# **Atlantic Coast Pipeline and Supply Header Project** *Final Environmental Impact Statement*

Docket Nos. CP15-554-000, CP15-554-001, CP15-555-000, and CP15-556-000  
 FERC/EIS-0274F

### **COMMENTS ON THE DRAFT EIS AND RESPONSES**

Figure 1. Alternative routes analyzed by DEQ that would bypass the Lewis Creek Watershed.

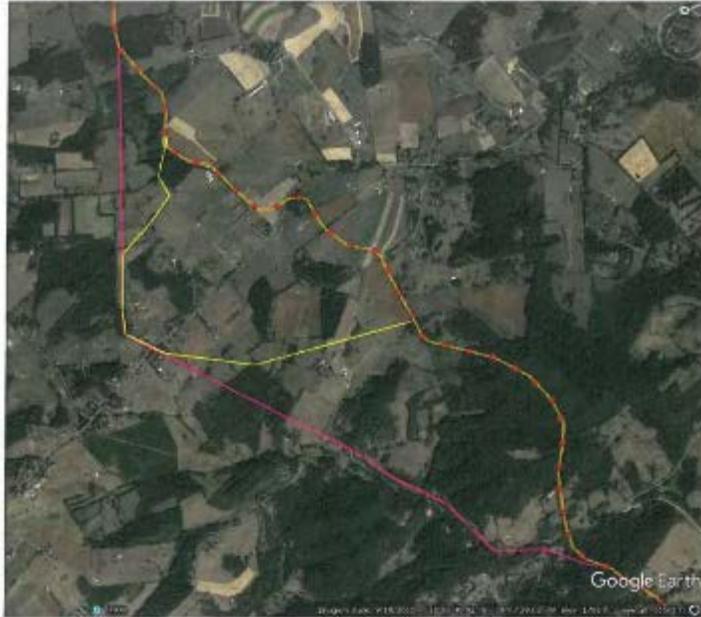
SA8-126  
(cont'd)

- The yellow route remains closest to the watershed boundaries and adds 0.8 miles to the pipeline project. The violet route follows a straighter path as it bypasses the Lewis Creek watershed. It adds 0.48 miles to the pipeline.

Figure 2. Alternative route analyzed by DEQ for ACP near the Elizabeth River.

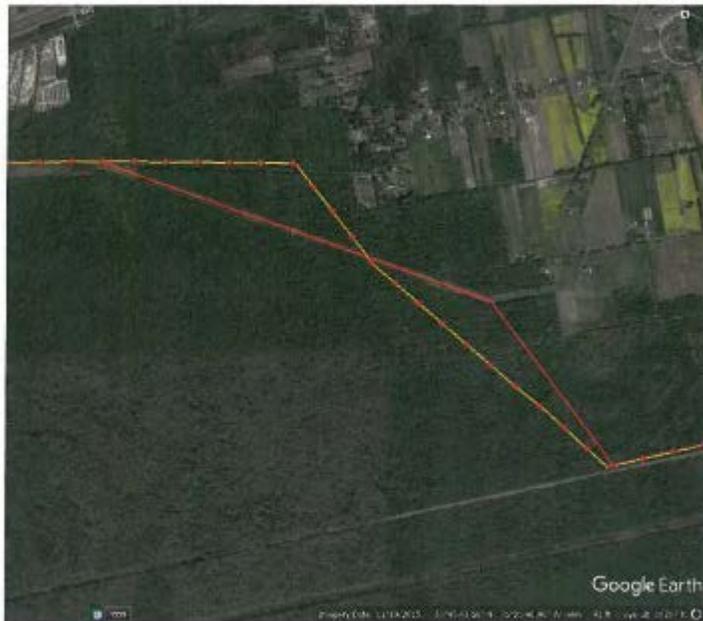
SA8-126  
(cont'd)

- oxygen, and aquatic plants. There are no known sources of PCBs that will be affected by the construction of the pipeline across these two water bodies.
- The final mile of the proposed pipeline construction crosses the Elizabeth River between Mileposts 81.8 and 82.0 parallel to the Military Highway drawbridge. The river is impaired for PCBs in fish tissue, as well as presence of dioxin and poor dissolved oxygen. The route appears to avoid documented point sources in this region; however, there is one opportunity to align the pipeline route better with an existing major power line easement. This alternative route will decrease the pipeline by approximately 0.05 miles, and reduce the loss of forested corridor by 1.35 miles. Figure 2 illustrates an alternative route that takes advantage of the existing power line easement that the ACP route already follows in part.

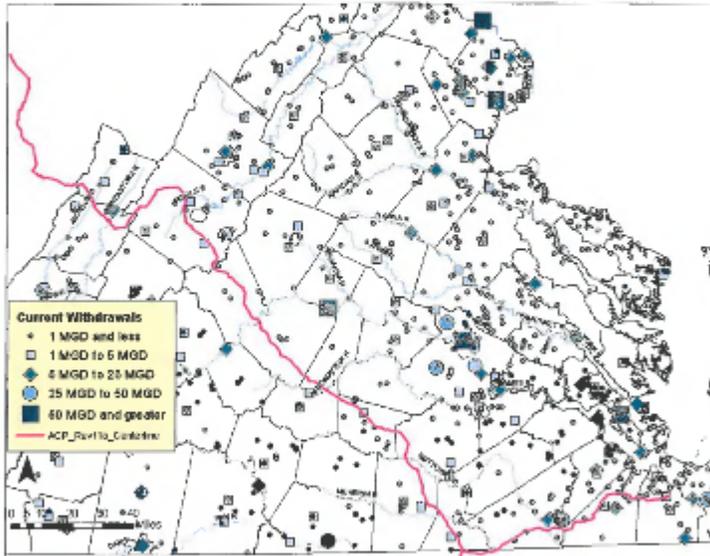
SA8-143

- Groundwater and surface water withdrawals in Virginia are depicted in the map below. It is evident the pipeline will be in close proximity to many of these sources. Dominion should communicate with water withdrawers regarding the construction, water withdrawal, and other activity that may impact the facilities.
